Model: Gim-P1c/Gim-P1d	Date: 21-Nov-14	No.: RM158003
------------------------	-----------------	---------------

Subject: Firmware Release Note: NetworkDocBox		Prepared by: Y. Gaman	
From: 3rd Tech Service Sect., MFP/Printer Tech Service Dept.			
Classification:	<input type="checkbox"/> Troubleshooting <input type="checkbox"/> Mechanical <input type="checkbox"/> Paper path <input type="checkbox"/> Product Safety	<input type="checkbox"/> Part information <input type="checkbox"/> Electrical <input type="checkbox"/> Transmit/receive <input checked="" type="checkbox"/> Other (Firmware)	<input type="checkbox"/> Action required <input type="checkbox"/> Service manual revision <input type="checkbox"/> Retrofit information <input checked="" type="checkbox"/> Tier 2

Subject: Dirty reverse side of printing sheets		Prepared by: J.Kitagawa	
From: 1st Tech Service Sect., MFP/P Tech Service Dept.			
Classification:	<input type="checkbox"/> Troubleshooting <input type="checkbox"/> Mechanical <input type="checkbox"/> Paper path <input type="checkbox"/> Product Safety	<input checked="" type="checkbox"/> Part information <input type="checkbox"/> Electrical <input type="checkbox"/> Transmit/receive

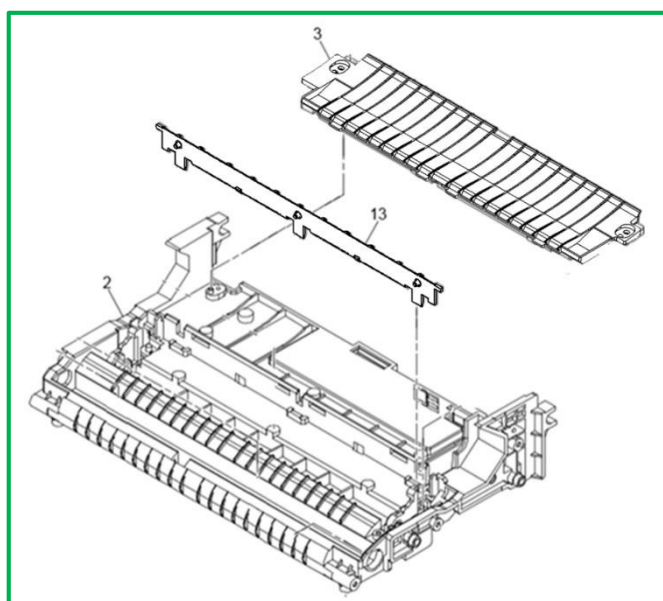
**Change:** The shapes and/or material of the following parts were changed.

1. The maximum height of the guide rib of the exit guide stay was shortened.
2. The material and shape of the electrode plate cover was changed.
3. The shape of the transfer stay was changed as shown in the illustration.

**Reason:** To further minimize staining on the printed paper.

**Note:** The reverse side of the printed sheets may get dirty when the sheets pass through the area indicated in the illustration.

**Important:** These three parts need to be installed **together as a set**.

Old

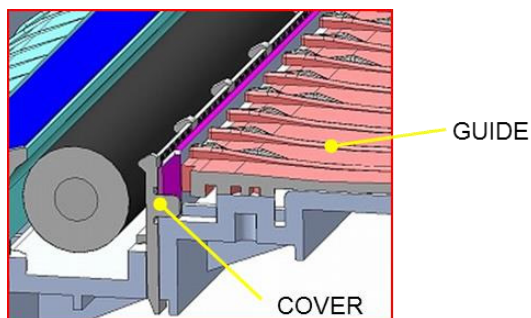
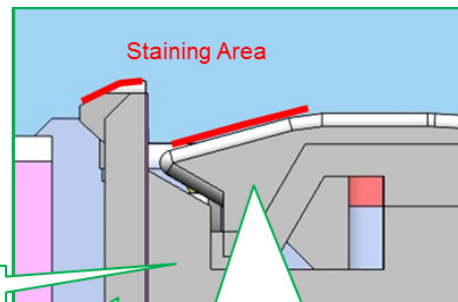
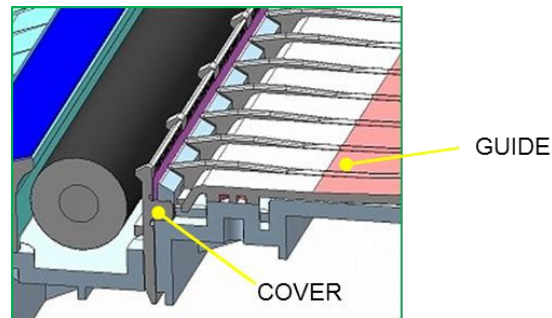
M1603850  
STAY:TRANSFER

M1603851  
GUIDE:EXIT:STAY:TRANSFER

M1603861  
COVER:ELECTRODE PLATE:SEPARATION

M1603870  
STAY:TRANSFER

M1603866  
GUIDE:EXIT:STAY:TRANSFER:2

M1603865  
COVER:ELECTRODE PLATE:SEPARATION:2

## 12. Fusing Section 1

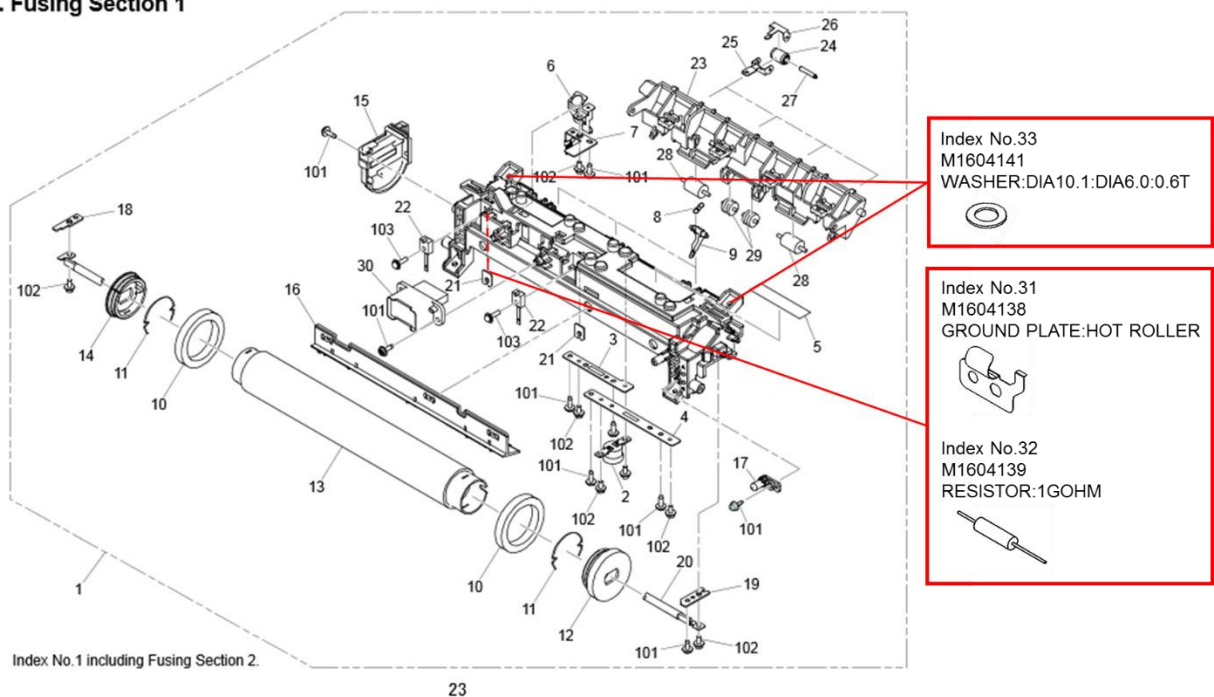
**Change:** Geometry of these parts has changed.

Incorrect part number	Correct part number	Description	Q'ty	Page	Index	Note
-	<b>M1604138</b>	GROUND PLATE:HOT ROLLER	1	24	31	
-	<b>M1604139</b>	RESISTOR:1GOHM	1	24	32	
-	<b>M1604141</b>	WASHER:DIA10.1:DIA6.0:0.6T	1	24	33

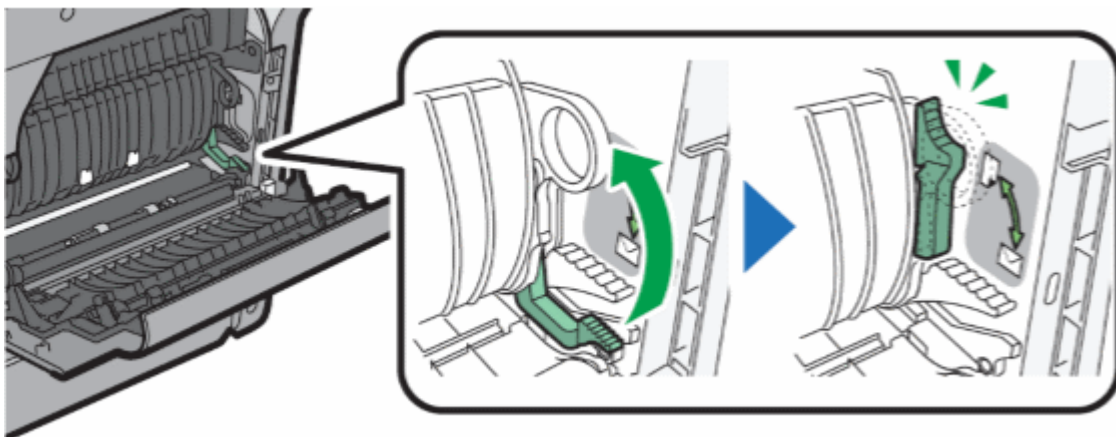
Toner is not properly fixed when printed on a recommended type of plain paper.

The lever is set to the low position for envelope printing.

Raise the lever to the high position.

M158.M159:EU/AA/CHN

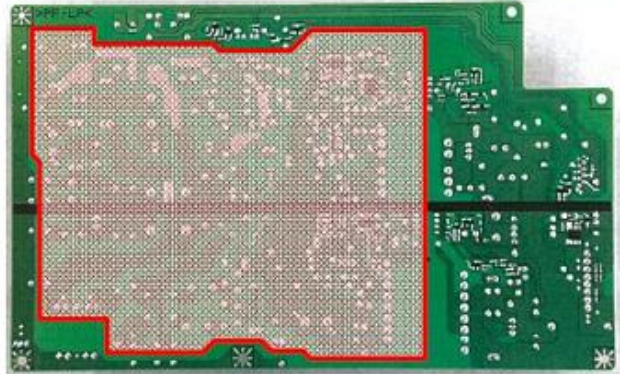
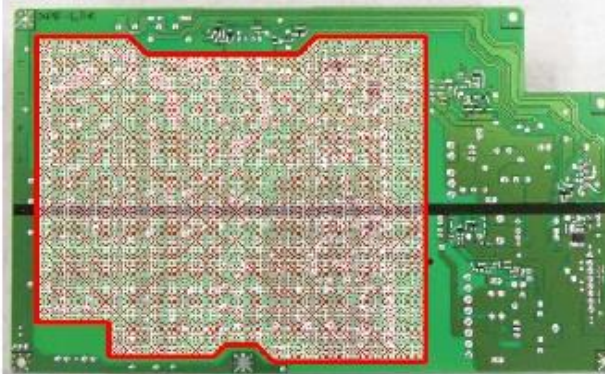
**NEVER touch** the areas outlined in red in the photos below to prevent electric shock caused by residual charge.

\* The areas outlined in red for M158,M159:DOM/NA were corrected.

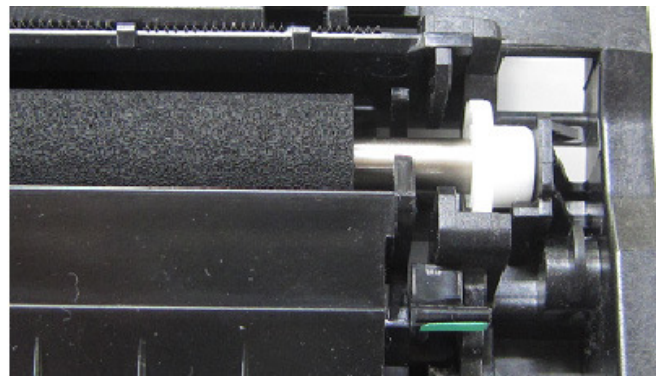
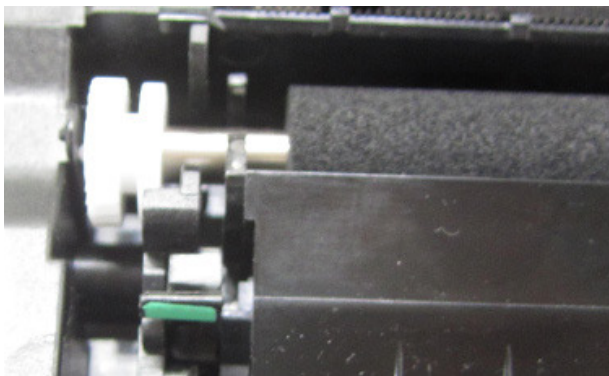
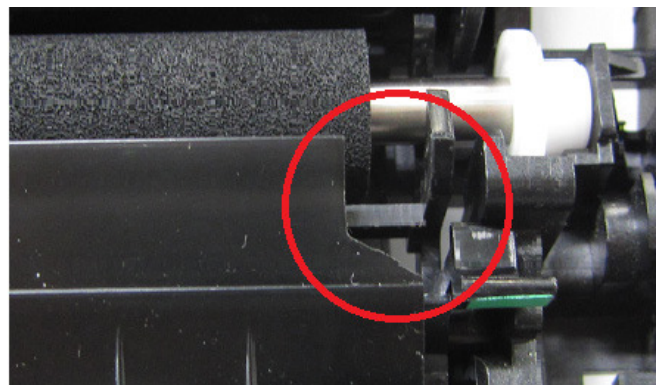
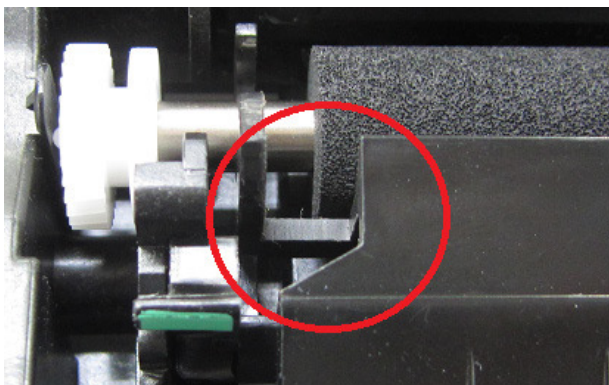
- A cut-out was applied to the right and left edges of the front paper guide of the transfer roller.
- Sponges and sheets were added to the transfer stay.

With this modification, dropped toner goes around the right and left edges of the front paper guide and accumulates on the transfer stay.

This modification has compatibilities. Since the old transfer stay cannot be replaced in the field and the stay of the old type is compatible only with the front paper guide of the old type, when replacing the front paper guide of an old machine, make sure to procure the old type.

This modification allows usage of the PCDU even after exceeding 23K by modifying SP5-931-003. However, DO NOT modify this SP on machines manufactured prior to this modification, because the front paper guide and transfer stay are both of the old type and will cause toner accumulation on the front paper guide when reaching approximately 23K.

Cleaning of the front and rear transfer roller guides is not mandatory for machines applied of this modification. However, note that the cleaning is mandatory for the machines manufactured prior to this design modification.

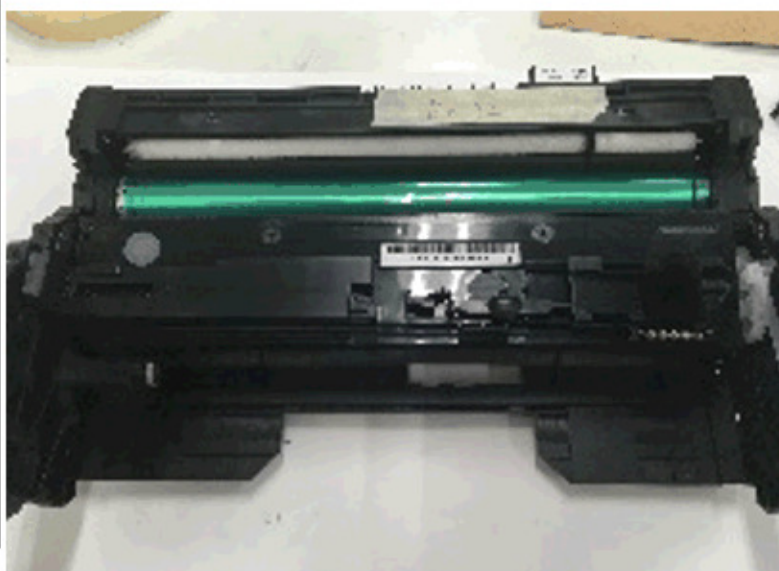
Black line or white line appears on prints in the feeding direction along with toner on the charge cleaning roller at the line position.

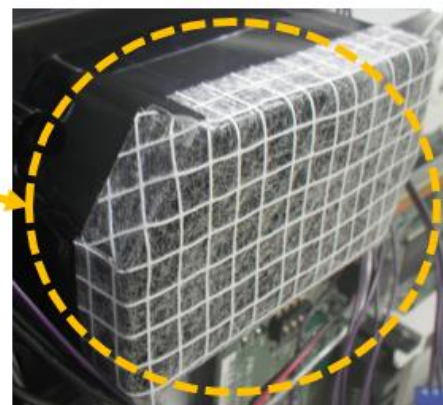
A filter sheet is added to prevent the entry of abnormal substances coming from the intake fan.

## 8. Paper Feed 1

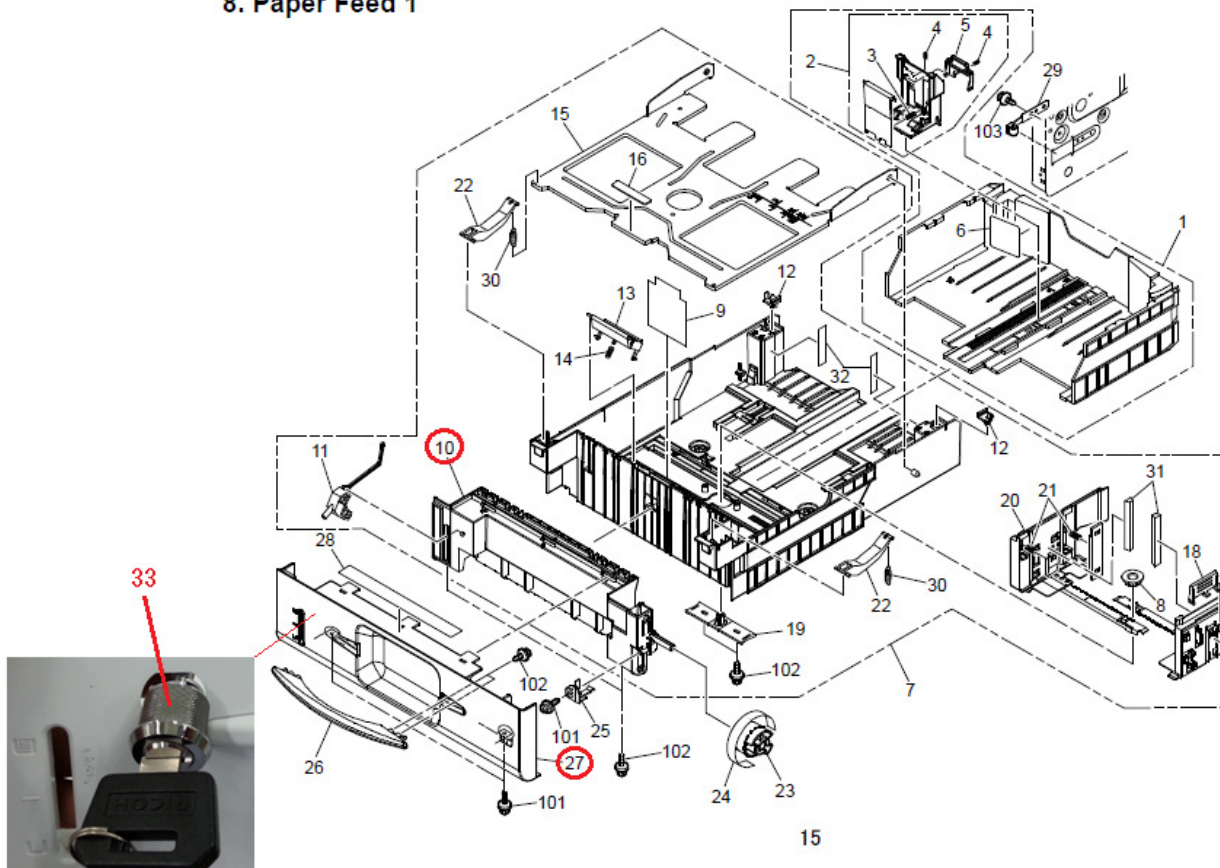
Section	P/N	Description	Page	Index
Paper Feed 1	M1602699	COVER:PAPER TRAY:500 SHEET FEED UNIT:KEY-LOCK	16	27
	M1602659	GUIDE:PAPER TRAY:500 SHEET FEED UNIT:KEY-LOCK		10
	M3752570	KEY:OPTION TRAY		33

Note: Two spare keys come with the part (M3752570).

## 7. Manual Feed Section 2

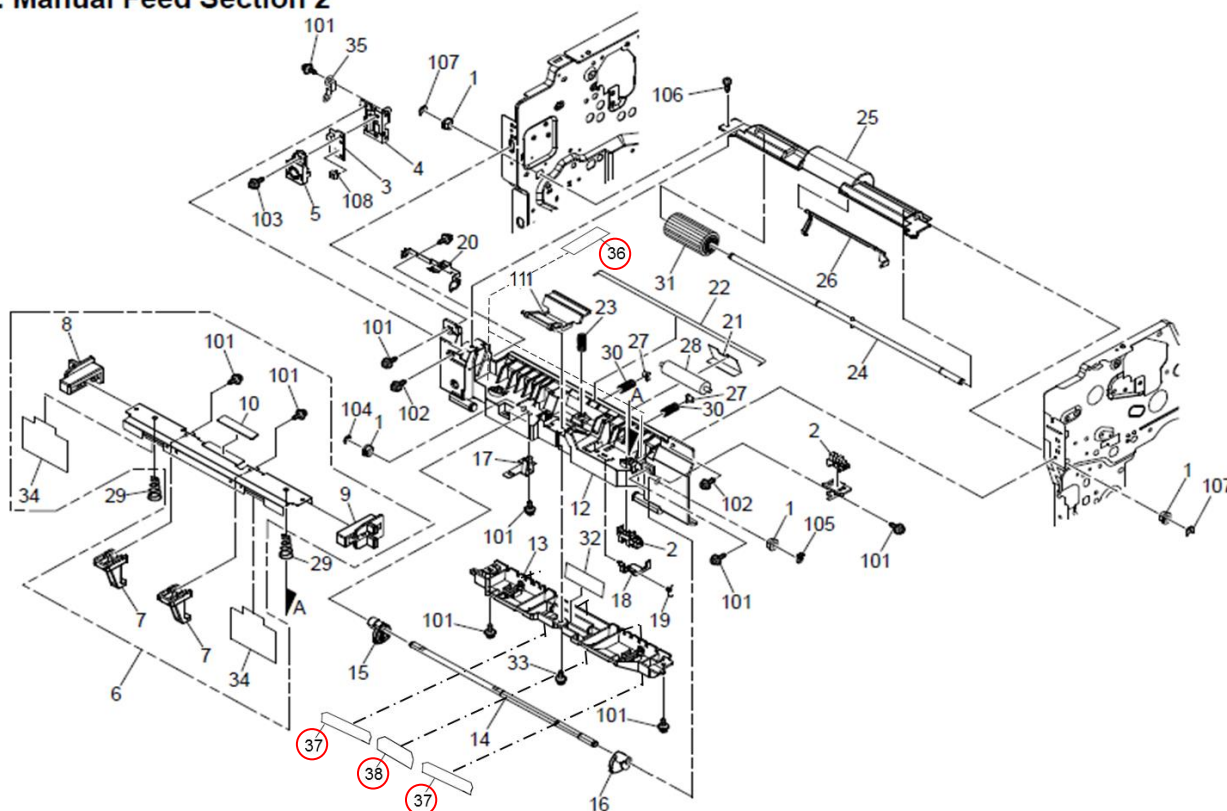
**Change:** The following parts were registered as service parts.

Old part number	New part number	Description	Q'ty	Page	Index	Note
-	M1602749	SHEET:GUIDE:MPT:LOWER	2	13	37	
-	M1602751	SHEET:ENTRANCE:MIDDLE:ROLLER	1	13	38	
-	M1602756	INSULATING SHEET:ENTRANCE:MF	2	13	36

## 16. Drive Section 1 |

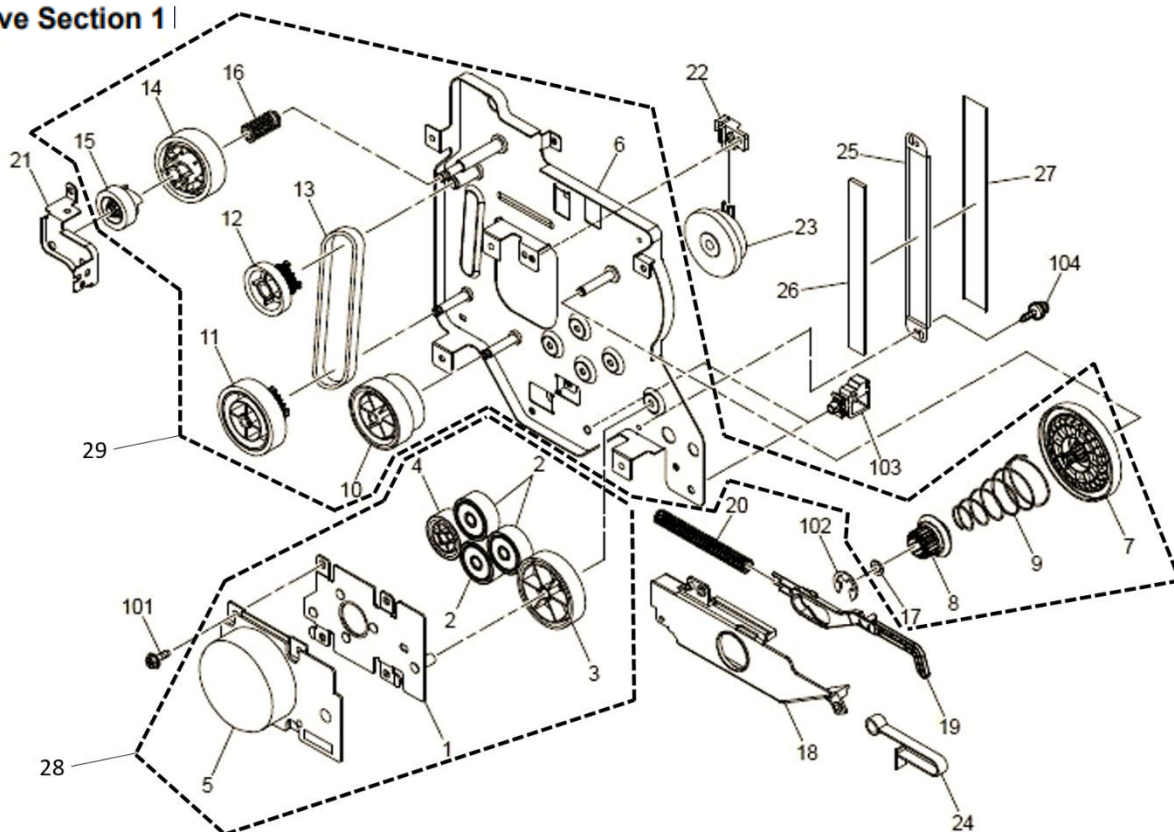
**Change:** The following parts were registered as service parts.
